**M E M O R A N D U M**  
**July 2<sup>nd</sup>, 2014**

**TO:** Landmarks Board

**SUBJECT:** Public hearing and consideration of an application for a Landmark Alteration Certificate to construct a one-story, 425 sq. ft., two-car garage, remove a portion of the contributing garage, and construct a fence along the north, south, east and property lines at 730 Pine St. in the Mapleton Hill Historic District, per section 9-11-18 of the Boulder Revised Code 1981 (HIS2014-00087).

Figure 9. Existing (l) and proposed (r) site plans.

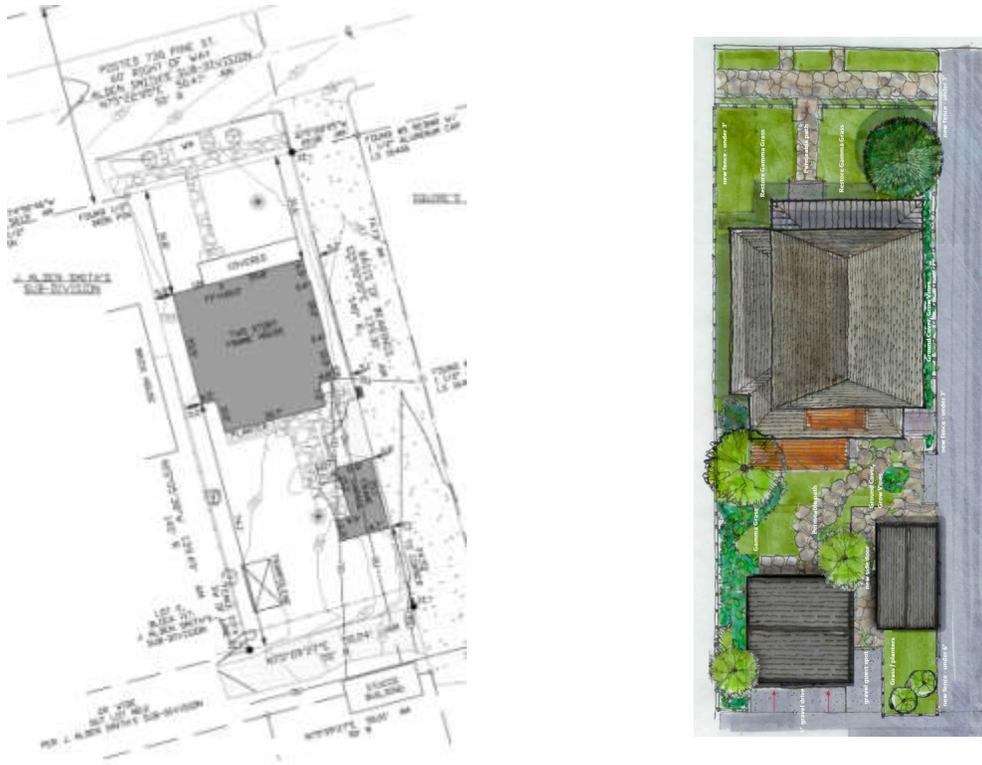
In plan, the proposed garage measures 22 ft. 6 in. by 22 ft. and is shown to be located toward the rear of the property, with alley access to the south. It is positioned approximately 37 ft. from the rear of the primary house, 5 ft. 3 in. from the west property line, 22 ft. from the east property line (alley side) and 5 ft. 4 in. from the south property line (alley side). Plans show a free-standing trellis to be located between the contributing garage and new accessory building. A rear deck, approved under a separate Landmark Alteration Certificate, is to be located at the rear of the primary house. Approximately 20 ft. of landscaped area would separate the proposed garage and rear deck on the house.

.2	<i>New garages and accessory buildings should generally be located at the rear of the lot, respecting the traditional relationship of such buildings to the primary structure and the site.</i>	As proposed, the new garage would be located 5 ft. 3 in. from the alley; setback of accessory buildings along this portion of the alley varies greatly. Applicant should confirm that adequate backing distance is proposed.	<b>Yes</b>
.3	<i>Maintain adequate spacing between accessory buildings so alleys do not evolve into tunnel-like passageways.</i>	Accessory building setback approximately 5 ft. 3 in. from the south property line and 8 ft. west of the contributing garage proposed location will not result in a tunnel-like passageway given the setback of the building from the south property line.	<b>Yes</b>
.4	<i>Preserve a backyard area between the house and the accessory buildings, maintaining the general proportion of built mass to open space found within the area.</i>	Proposed garage shown to be located 5 ft. 3 in. from the alley, 6 ft. from the east property line and approximately 36 ft. from the south wall of the main house. This will allow for adequate back yard space.	<b>Yes</b>

Figure 10. Proposed south elevation

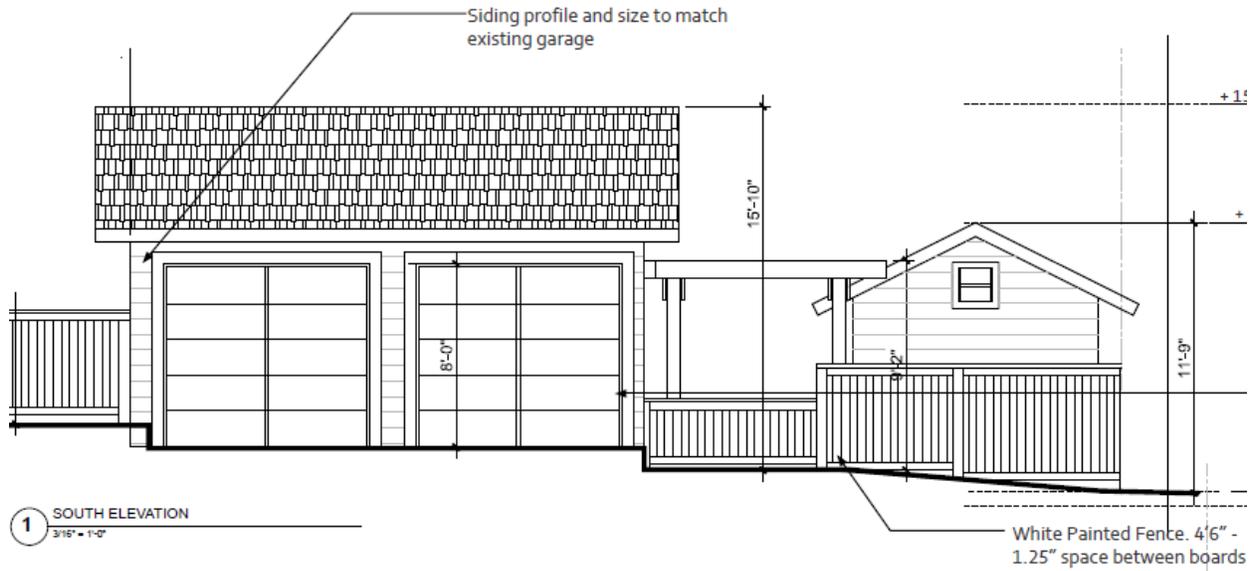
The garage is proposed to have simple a one- story side gable form with the south elevation featuring two multi-panel garage doors.

Figure 11. Proposed east elevation (facing alley)

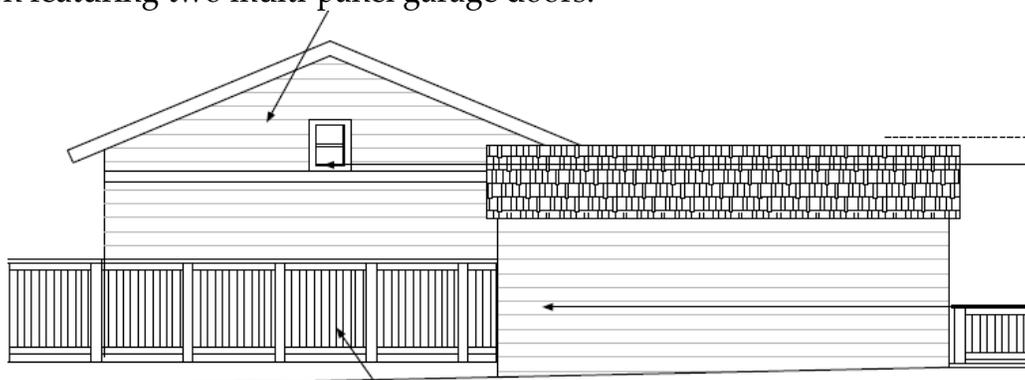
The proposed east elevation of the building features a double-hung window on the upper level.

.10	<i>Windows, like all elements of accessory structures, should be simpler in detailing and smaller in scale than similar elements on primary structures.</i>	Proposed design of windows on east and west elevations appear to be compatible in terms of window type, size and detailing with similar elements on the primary building.	<b>Yes</b>
.11	<i>If consistent with the architectural style and appropriately sized and located, dormers may be an appropriate way to increase storage space in garages.</i>	N/A	<b>N/A</b>
.12	<i>Garage doors should be consistent with the historic scale and materials of traditional accessory structures. Wood is the most appropriate material and two smaller doors may be more appropriate than one large door.</i>	Garage doors proposed to be insulated steel; appear to be consistent in terms of scale and materials. Review final details at Ldrc.	<b>Maybe</b>
.13	<i>It is inappropriate to introduce features or details to a garage or an accessory building in an attempt to create a false historical appearance.</i>	Proposed design does not attempt to recreate a false historic appearance.	<b>Yes</b>

Figure 12. Proposed west elevation

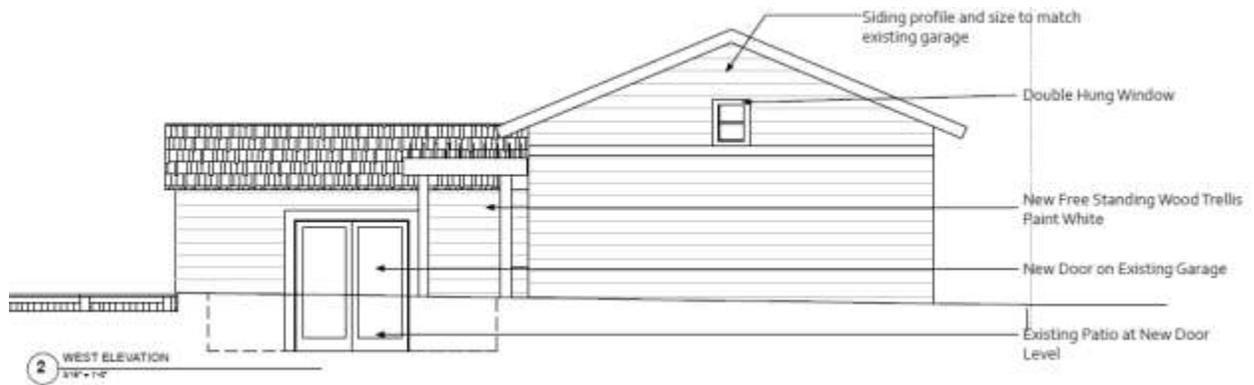
The proposed west elevation is shown to also feature a double-hung window on the gable matching that on the east face of the garage. The building is shown to be sided with wide clapboard siding similar to that on the existing contributing garage.

Figure 13. Proposed north elevation (interior lot)

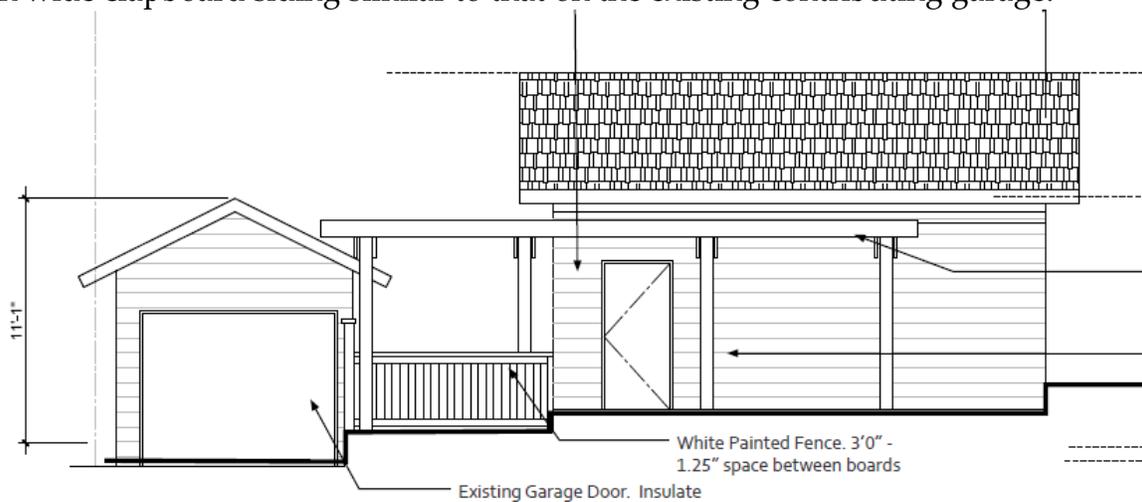
The proposed north elevation, facing the rear of the main house, features a pedestrian door while a three bay pergola is shown to be located between the contributing garage and proposed new garage.
